Access Compliance Report

Public Rights-of-Way

(Pedestrian Signals)

Intersection ID: N/A	Main Street:	Cross Street: N/A	Location: N/A
ADA ID: 37FD7D4FCFF4	Signal Type: One Push Button-Non APS	Overall Compliance: No	Severity Score: BTN 1: N/A BTN 2: N/A No BTN: N/A
Codes/Mitigation Info/Possible Solution		Field Measurements/Component Compliance

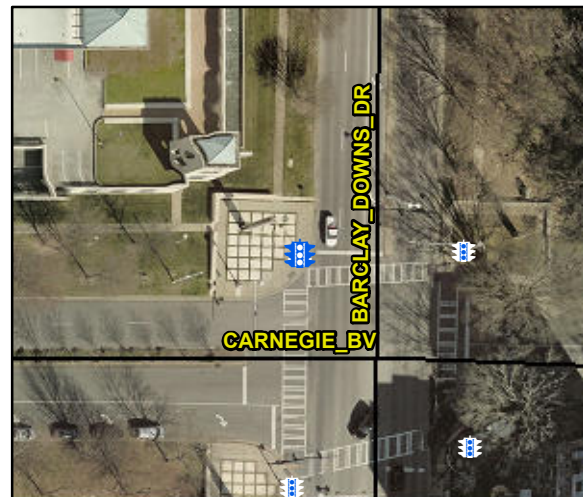
Possible Solutions: Replace Signal Push Button With APS Button on New Post. Remove & Relocate Sign.

PROW/ADA: TMUTCD 4e.08, R404.2, R404.3, R406.2
